Request for Renewal of IP 0001/05 (IPPC Permit for Ta' Zwejra)

Consolidated Application

IP 0001/05
Ta' Zwejra Non-Hazardous Waste Landfill
Condition 3.13 - Improvement Programme
Status - September 2010

Monitoring Plan for the Non-Hazardous Waste Landfill at Ta' Zwejra

Figure 9.1: Proposed coastal monitoring points

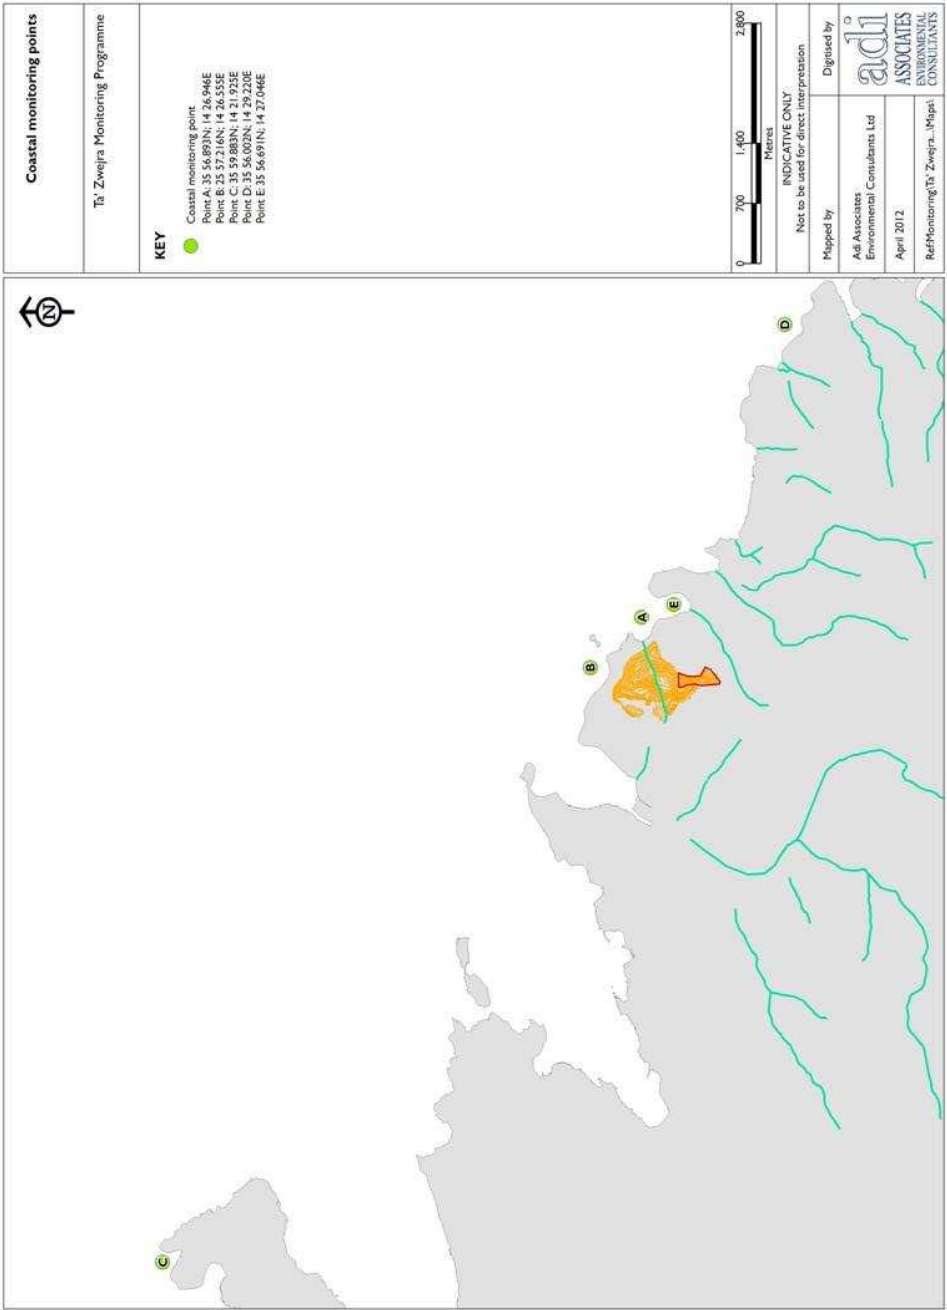
Monitoring	Assessment of proposal	Further submissions/clarifications required	Adi Associates comments
<p>Coastal water and sediment</p>	<p>Impact from Żwejra is expected to be adequately assessed through this monitoring. However, dioxins/furans are to be included, in line with the approved Ghallis monitoring programme, and some other parameters in view of new Water Framework Directive Obligations.</p> <p>Acceptable, subject to the following changes:</p> <p>(1) Inclusion of dioxins/furans (PCDDs/PCDFs) monitoring in sediment and water.</p> <p>(2) Inclusion of brominated diphenylether, C10-C13 chloroalkanes, DEHP (di(2-ethylhexyl)-phthalate), fluoranthene, pentachlorobenzene and five PAHs in sediment (as per Directive 2008/105/EC, Annex I).</p> <p>(2) Addition of Qalet Marku as a monitoring point (this can be carried out instead of point D; the interpretation of the results from this point can also take into account input from agricultural sources).</p> <p>(3) Inclusion of the updated monitoring points on a close-up map of the area, including coordinates, superimposed on main water catchment of the area.</p> <p>Additional notes:</p> <p>(1) Annual sediment monitoring is sufficient, to be carried out in the same time of year if annual.</p> <p>(2) Quarterly water analysis is sufficient.</p> <p>(3) Agreed with inclusion of recommended physico-chemical parameters.</p>	<p>Proposal to be updated accordingly.</p> <p>Note: This data is to be reported in both the Żwejra and Ghallis AERs.</p>	<ol style="list-style-type: none"> 1. Dioxins and furans added in Tables 9.1, 9.3 and 9.4. 2. Included in Table 9.1. 3. Moving Station D to Qalet Marku is not advisable as this means that only one reference site (Station C) will be left outside the potential influence of the Landfill. Consequently, if there will some problem at Station C, it will not be possible to compare the results obtained from Stations A, B and C to an alternative reference site. The supporting rationale for this may be found in Underwood A. J. (1997), Experiments in Ecology, Cambridge University Press. If the MEPA require monitoring inside Qalet Marku, this should be achieved by adding a monitoring station at that site. For this reason we are proposing a fifth station, Station E (refer to updated Figure 9.1).
